Allied Paper, Inc./Portage Creek/Kalamazoo River Superfund Site
Willow Boulevard/A-Site Landfill Operable Unit 2
Responses to Draft Comments on the Preliminary Design Report

GEORGIA-PACIFIC LLC
ALLIED PAPER, INC./PORTAGE CREEK/KALAMAZOO RIVER SUPERFUND SITE
WILLOW BOULEVARD/A-SITE LANDFILL OPERABLE UNIT 2 REMEDIAL DESIGN

**RESPONSES TO USEPA/CH2M HILL'S AUGUST 4, 2010 DRAFT COMMENTS ON THE
WILLOW BOULEVARD/A-SITE LANDFILL OPERABLE UNIT 2
PRELIMINARY DESIGN REPORT, JULY 2010**

FIGURE 11

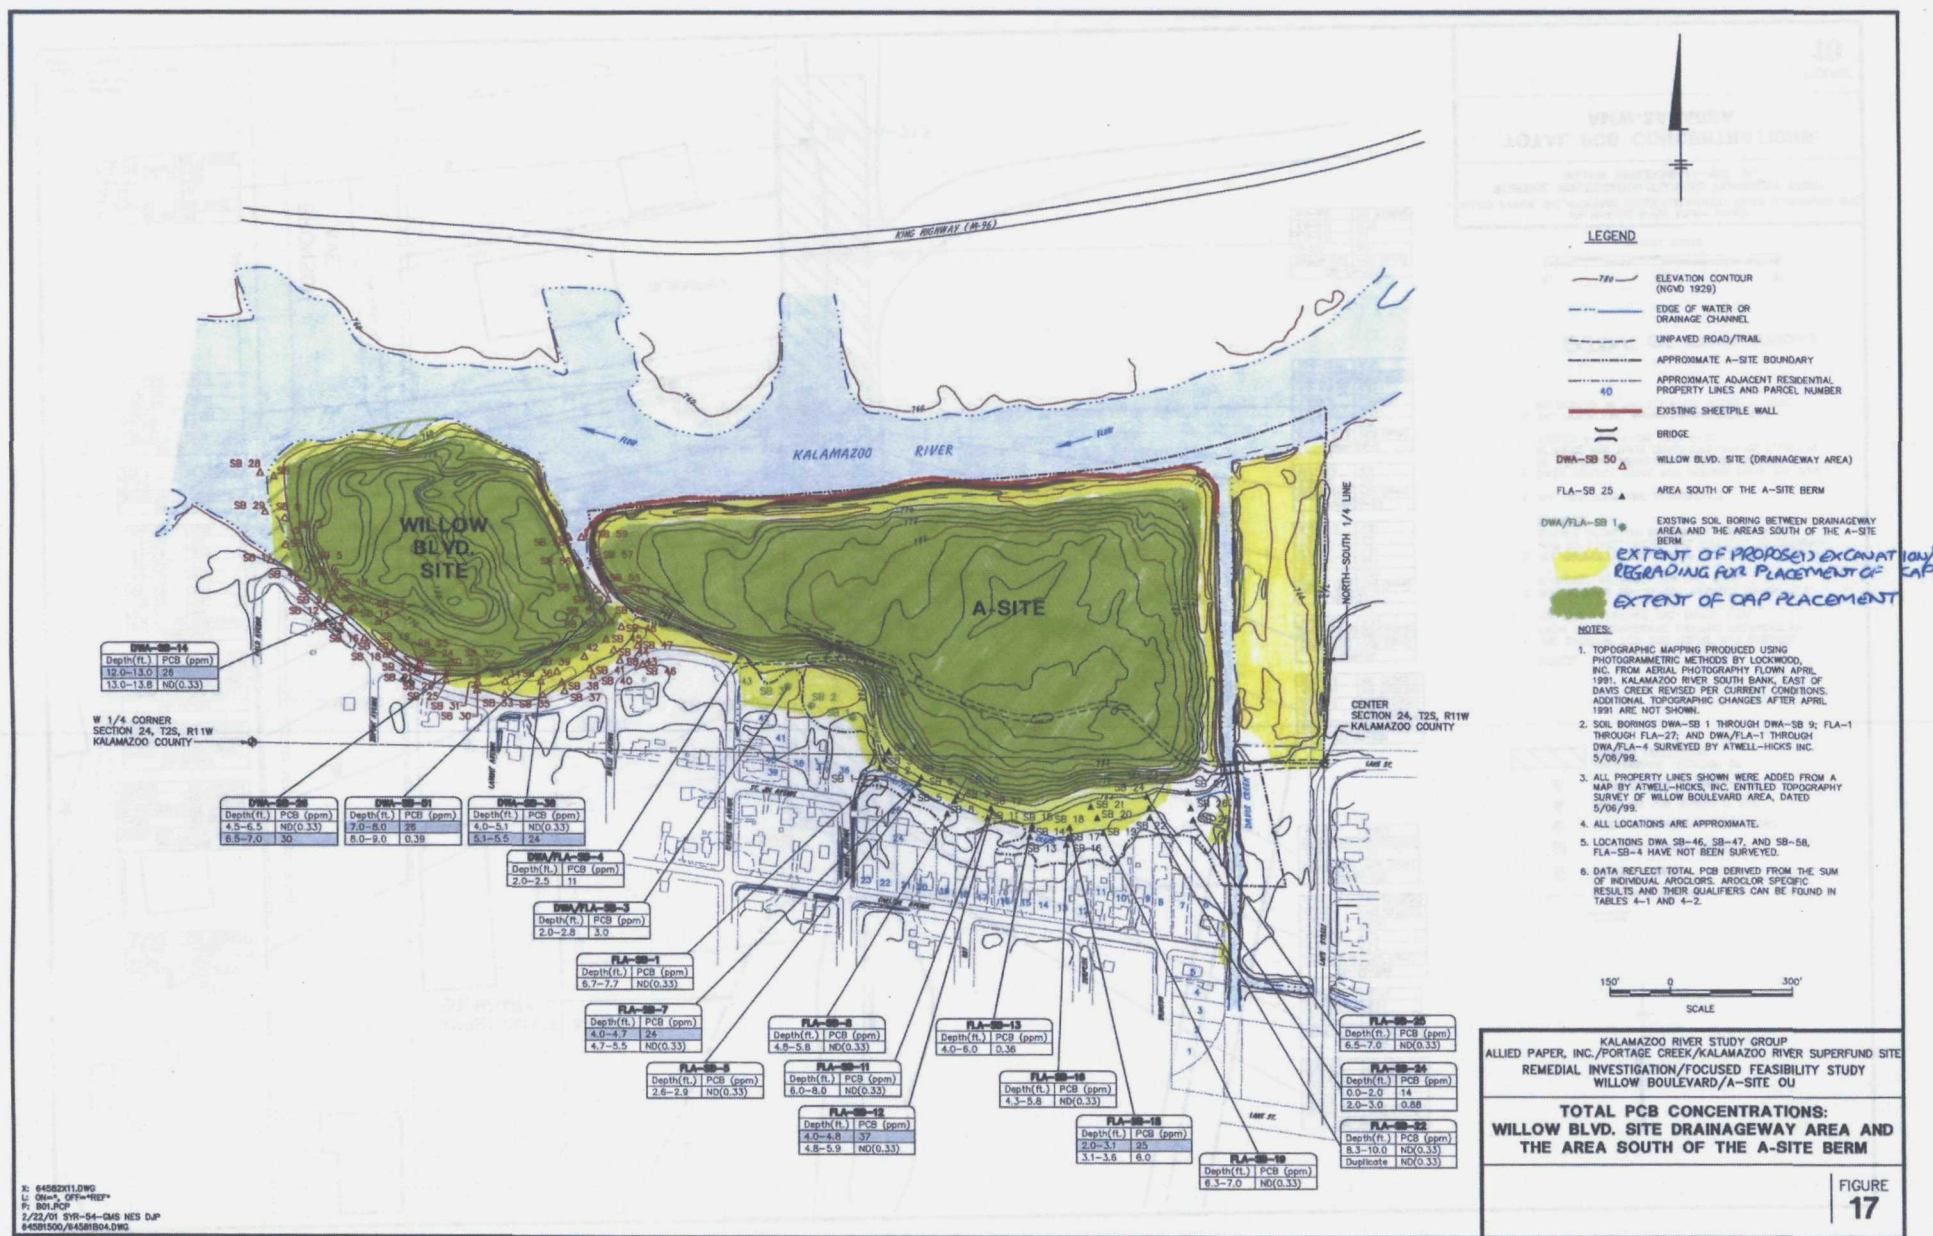
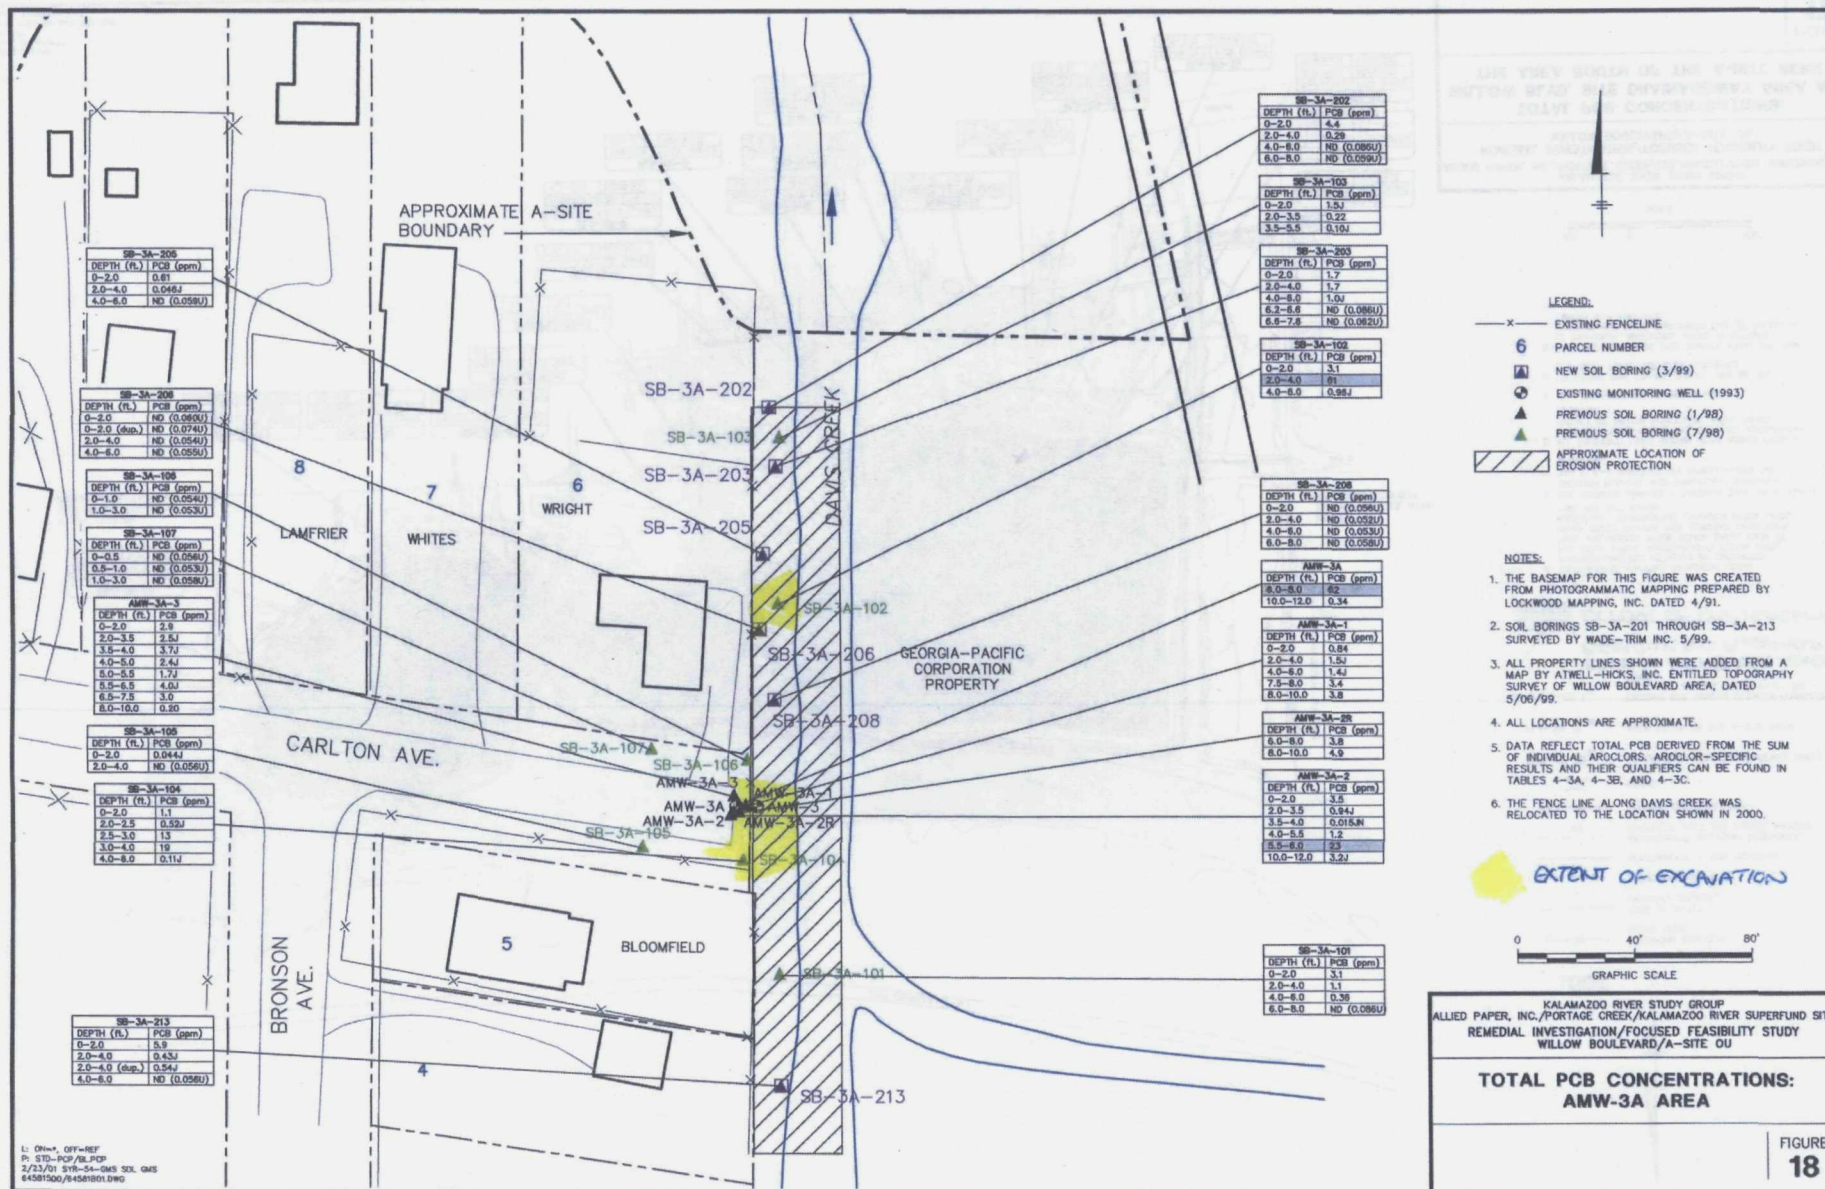
The attached figures, which were provided in the Preliminary Design Report, have been marked up by hand to identify those areas of the Operable Unit (OU) where excavation/major regrading is proposed and the extent of the proposed cover system for both landfills. The areas of excavation, the extent/footprint of residuals and PCB-containing materials after excavation, and the footprint of the final cap/cover systems will not change, regardless of where the materials are ultimately disposed.

FIGURE
2-4

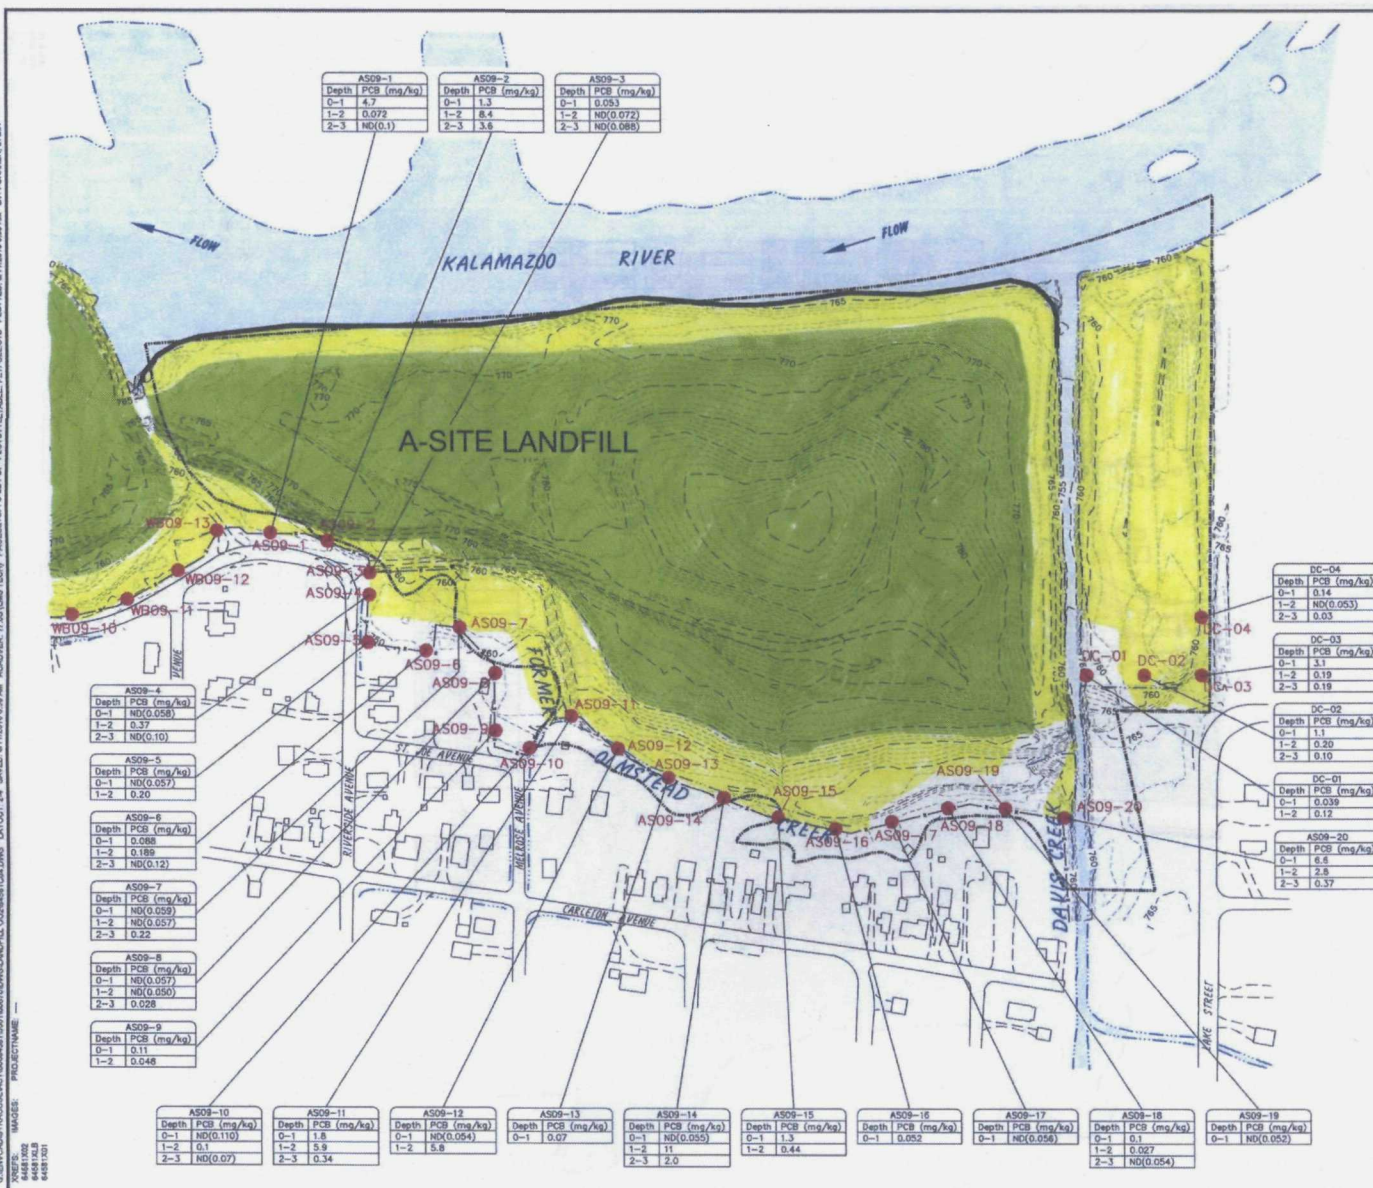
The attached figure shows the updated proposed excavation areas and limits of the cap within the Willow Boulevard Drainageway, assuming excavation to a 0.33 mg/kg criterion. The revised extent of excavation includes one additional area around sample location WB09-09 that was previously excluded based on application of the 6.5 mg/kg criterion, as the maximum PCB concentration in this sample is 0.59 mg/kg. The extent of excavation may also be revised as applicable in the Pre-Final Design Report.
